Proposed Amendments to the Streetscape and Sidewalk Improvement Standards

Proposed Amendments to the Uptown Temecula Specific Plan

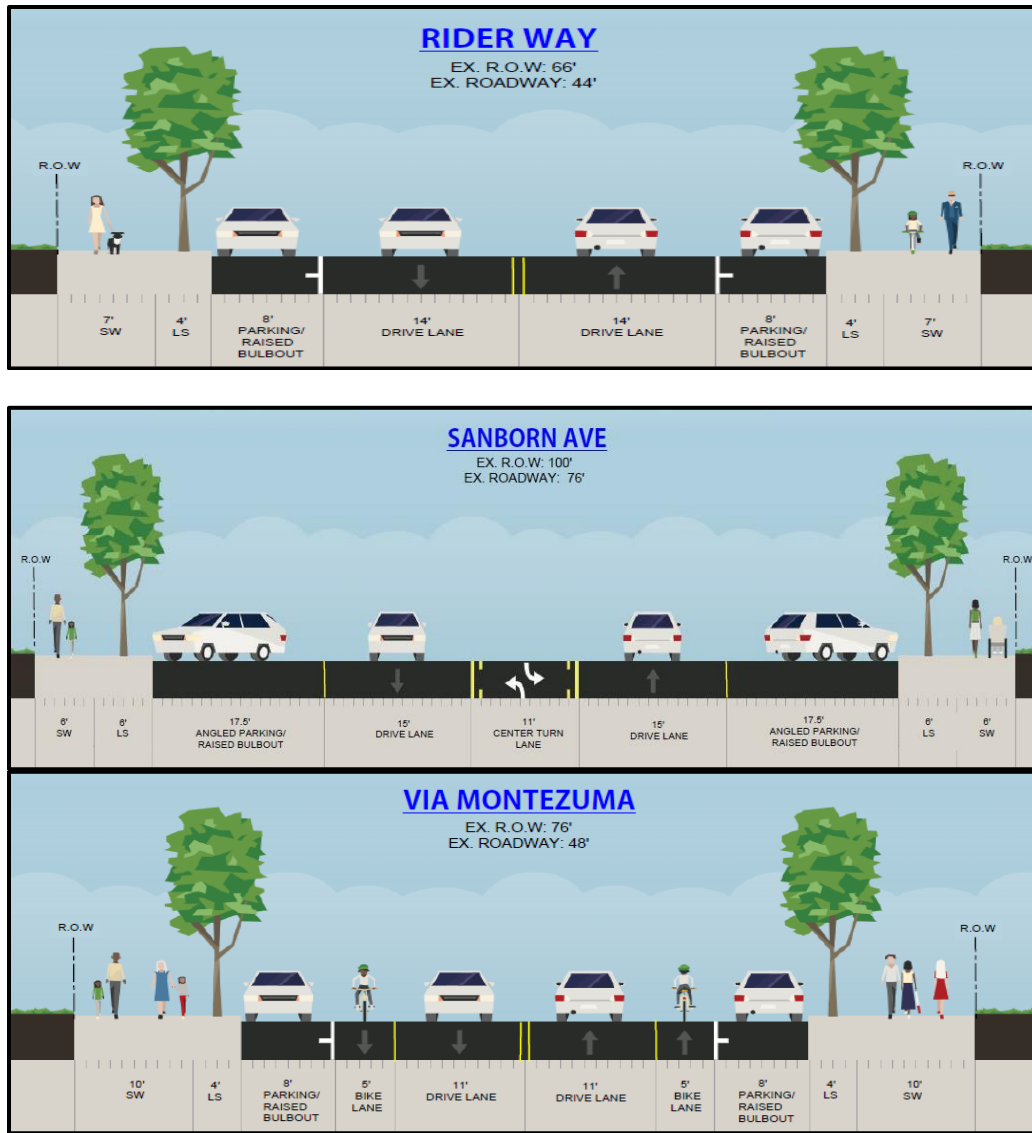
- c. Section I Street Cross Section Standards – Replace the existing street cross sections with the following:

Exhibit 1: Proposed ~~Hypothetical~~ Development of New Streets

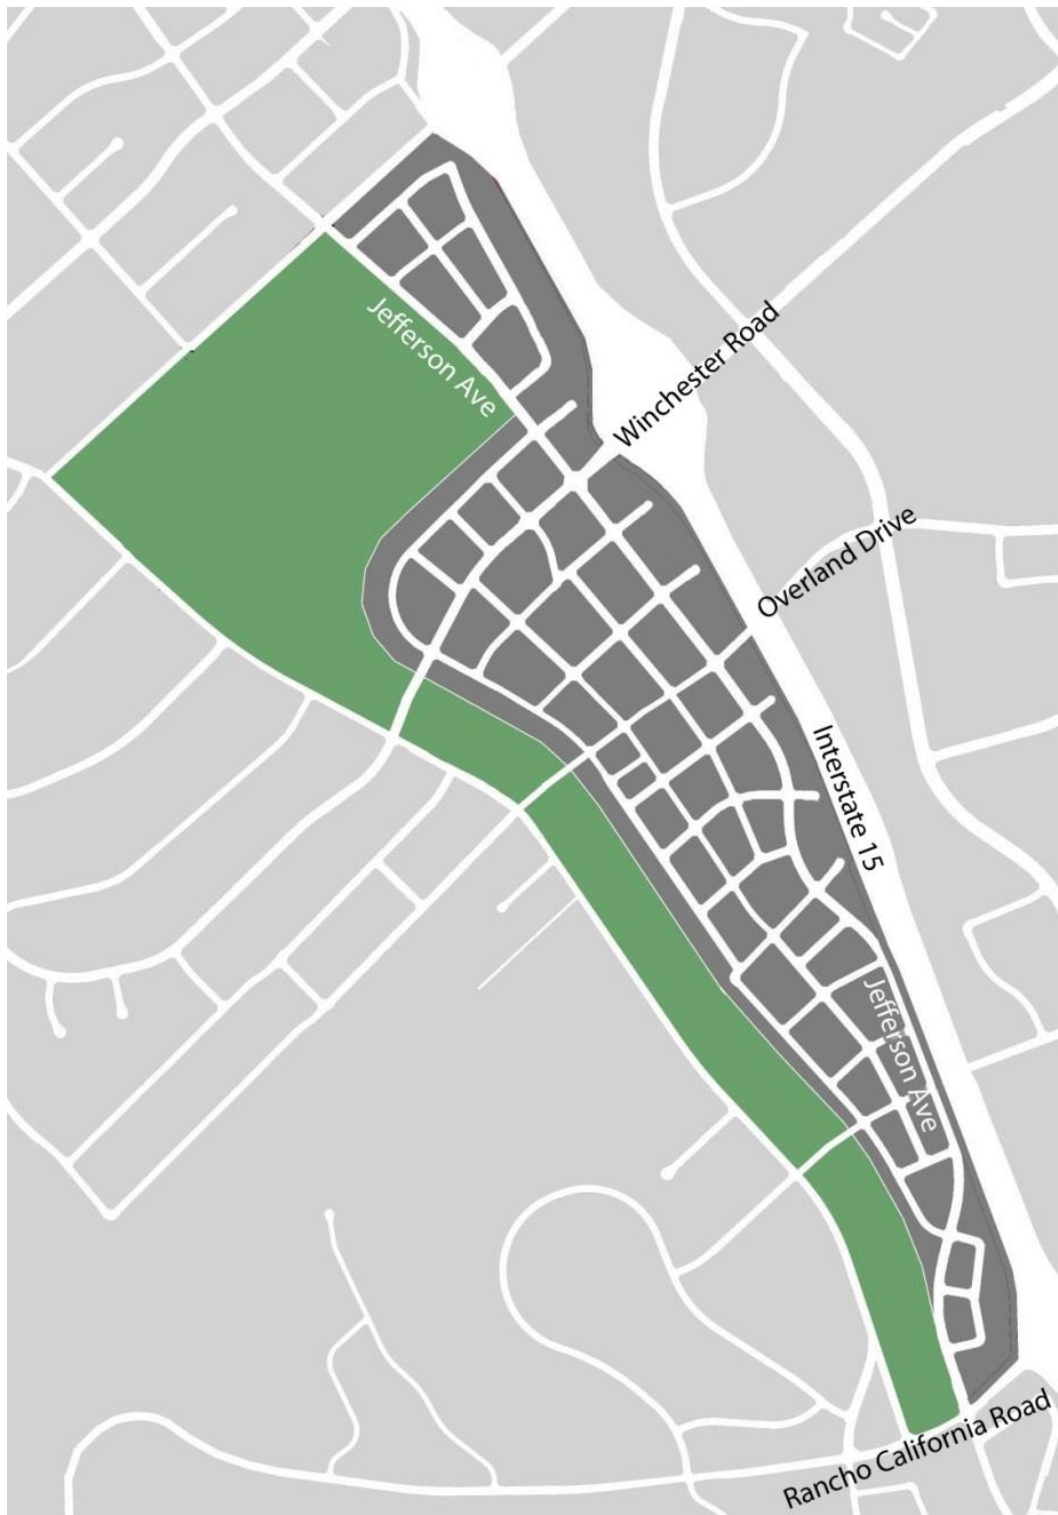
- g. Exhibit 3-13 – Change the title of the exhibit from “Hypothetical Development of New Streets” to “Proposed Development of New Streets” and correct any reference throughout the section

Exhibit 3-13 illustrates the proposed ~~hypothetical~~ development of a street grid in future Uptown Jefferson. The sketch on the left illustrates the existing street grid, and the sketch on the right illustrates proposed ~~potential~~ future streets (dashed lines) that could be added to the existing network. The result is a network of smaller blocks which are more walkable and pedestrian-scaled.

Exhibit -2: Proposed Hypothetical Street Network

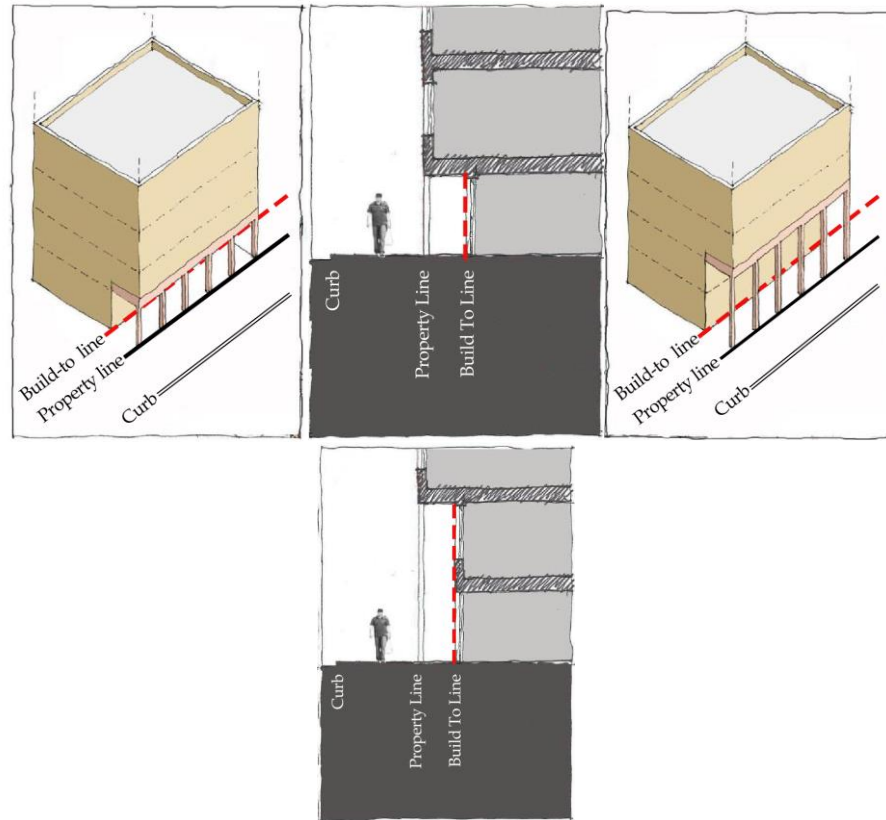
- h. Exhibit 3-14 – Change the title of the exhibit from “Hypothetical Street Network” to “Proposed Street Network” and correct any reference throughout the section

- i. Table 3-14 Block Standards – Add a reference to the bottom of the table referring to the road alignment study required for new roads and any deviation would require the written approval of the Director of Public Works

New development projects that propose or require new roads as part of their development shall submit, at the time of application, to the Director of Public Works for approval, a road alignment study that either demonstrates conformity to Exhibit 3-13: Proposed Street Network or provides an alternative road alignment study which shall demonstrate strict adherence to Table 3-14: Block Standards and provide equal or greater connectivity as Exhibit 3-14: Proposed Street Network.

Exhibit -3: High Fall Arcade Site Plan View

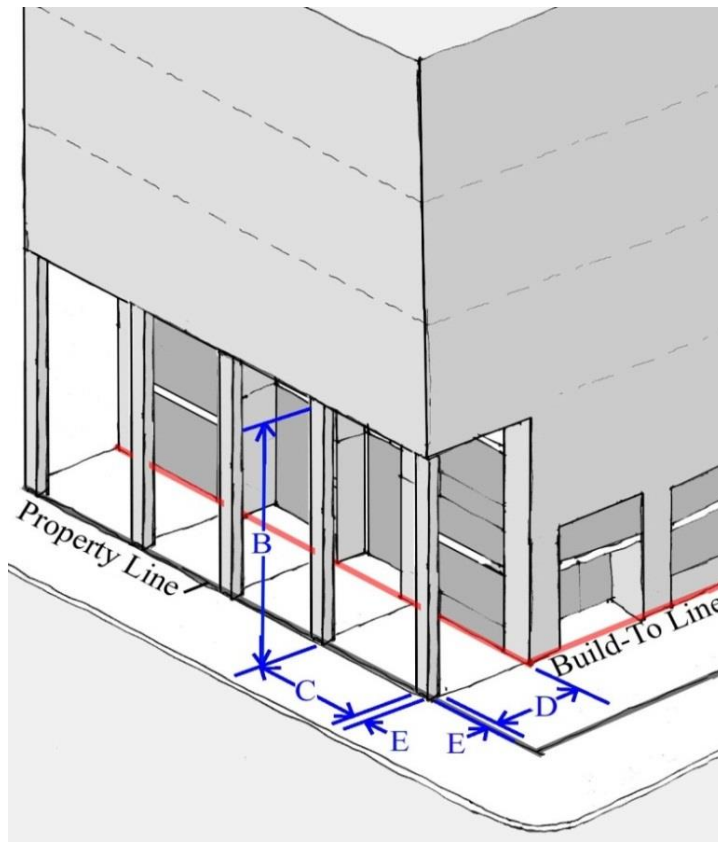
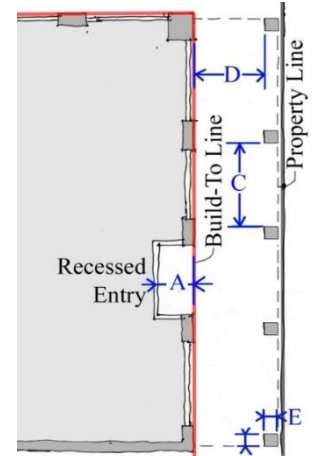
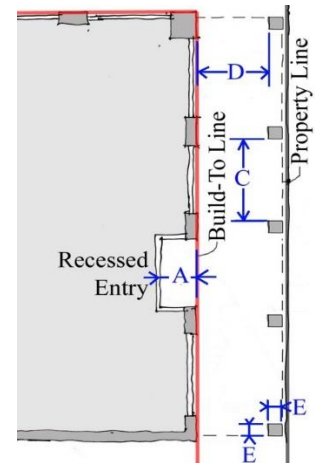
- a. Exhibit 4-11 Allowable Frontage Types – Modify the graphics to show the correct building placement for Arcade and High Arcade frontage types

- c. Exhibits 4-18, 4-19, and 4-20 – replace “Tall Arcade” with “High Arcade” for consistency
